## Recall Information Bulletin

**No:** R3150410 **Issued:** 12/13/2005

**Re:** 4M50 Idler Shaft Bolt

Safety Recall R3150410 - 4M50 Idler Shaft Bolt

DIAGRAM 1

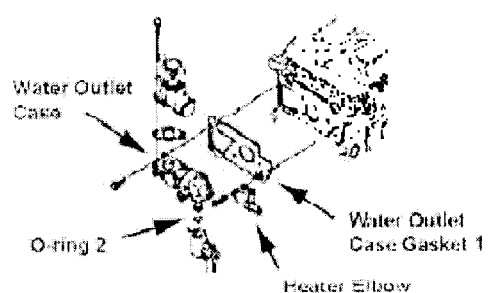
3. Remove the water outlet case, as shown in **DIAGRAM 1**, and clean off all remaining gasket material from both the outlet case and cylinder head surfaces. Remove and discard the heater elbow o-ring 2.
4. Attempt to loosen the idler gear shaft flange bolt 11 by hand (see **DIAGRAM 2**).
  - If the flange bolt **CANNOT** be loosened by hand, the idler gear assembly is reusable. Perform steps 5 - 8. **DO NOT PROCEED TO STEPS 9 - 21.**
  - If the flange bolt **CAN** be loosened by hand, the idler gear assembly must be replaced. **SKIP STEPS 5 - 8.** Proceed to steps 9 - 21.

PHOTO 1

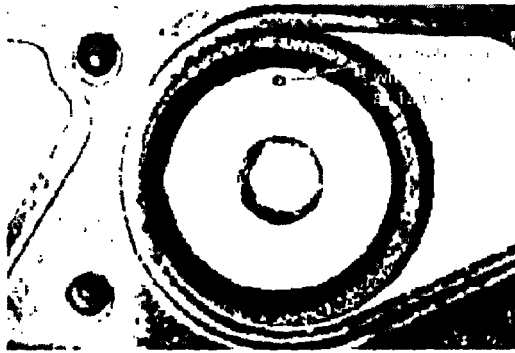
**Reassembly procedure with idler gear bushing replacement (DIAGRAMS 2 & 3 and PHOTOS 1 & 2):**

9. Temporarily tighten the idler gear shaft flange bolt to ensure that the thrust washer remains in place.
10. Loosen and remove all engine accessory drive belts.
11. Remove the A/C compressor (if equipped).
12. Remove the injection pump to injection nozzle fuel pipes.
13. Remove the fuel leak-off pipe.
14. Remove the rocker cover and discard the rocker cover gasket 4.
15. Remove both the intake and exhaust rocker shaft assemblies.
16. Remove the camshaft frame and both the intake and exhaust camshaft assemblies, and clean off all remaining gasket material from camshaft frame.
17. Remove the idler gear shaft flange bolt 11, shaft 10 and gear assembly 9.

DIAGRAM 2

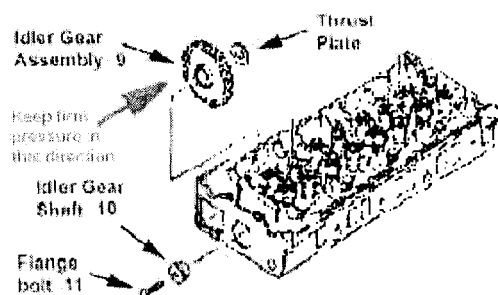
5. Remove the existing idler gear shaft flange bolt 11. **IMPORTANT! Keep light constant pressure on the idler gear shaft 10 toward the rear of the engine when replacing the flange bolt 3 to ensure that the thrust plate does not drop into the engine.**
6. Install a new idler gear shaft flange bolt 3, ensuring that the mark on the idler gear shaft 10 remains in the 12:00 position as shown in **PHOTO 1**. Torque the flange bolt 11 to 38.0 ft.lbs.
7. Reinstall the water outlet case with a new case gasket 1 and o-ring 2. Torque the water outlet case attaching bolts to 17.4 ft.lbs.
8. Refill the cooling system with the saved coolant.

DIAGRAM 3

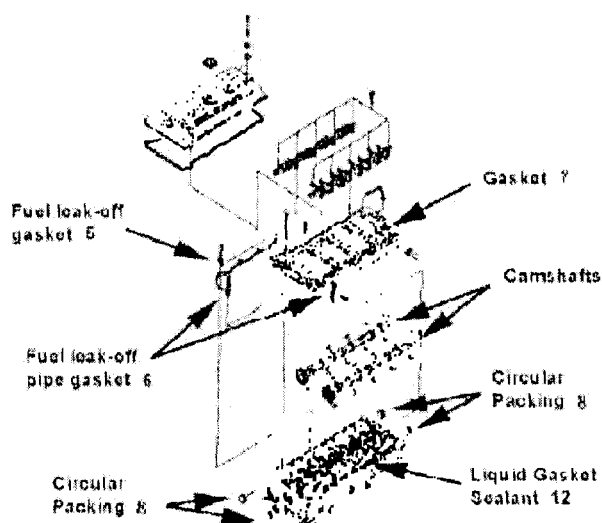
18. Install a new idler gear assembly 9, idler gear shaft 10 and flange bolt 11. Torque the flange bolt 11 to **38.0 ft.lbs.**
19. Reinstall all removed components in the reverse order of steps 3, 9 - 16 above.
20. When reinstalling the camshaft assemblies, place piston # 1 at top dead center on the compression stroke and align the camshafts with the alignment marks on the camshaft gear and the camshaft frame (refer to **PHOTO 2**).  
**NOTE: Review Service Information Bulletins 00-013 and 00-015 for more information concerning camshaft installation.**
21. Install new gaskets and sealants provided in parts kit **LT-32-A (Items 5,6,7,8 & 12)** and refill the cooling system with the saved coolant.
